Subject: Description of Permissive Change

We, Jiangsu Yuyue Medical Equipment & Supply Co., Ltd. hereby authorize Bay Area Compliance Laboratories Corp. (Kunshan) to act as a laboratory for testing and test report generation for the following project(s):
FCC ID: 2A2JJYE650ARS
Model Name: YE650AR
Original Grant Date: 2024/05/21

Original	CIIPC

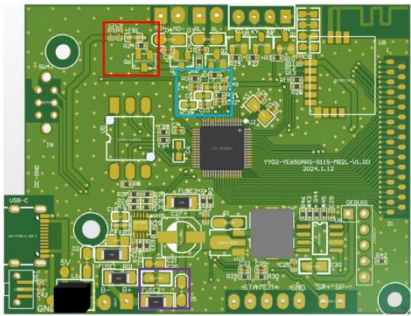
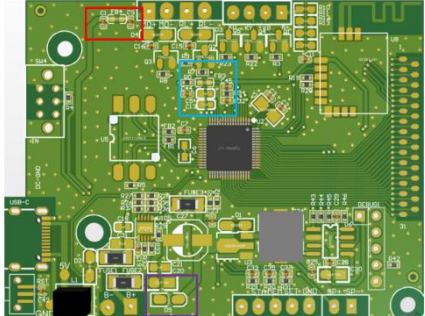
1. The red part modifies the air pump control circuit and component layout, the blue part modifies the layout of microcontroller peripheral devices, the purple part modifies the fuse position and removes a 0 Ω resistor.
2. YE650AR IP classification is changed from IP20 to IP21, and its structure is adjusted as follows: reduced 0.45mm thickness for top cover buttons, and a 0.45mm thick, 2mm wide foam has been added to the panel button area.
3. Change the tested model from “YE650ARS” to “YE650AR”.
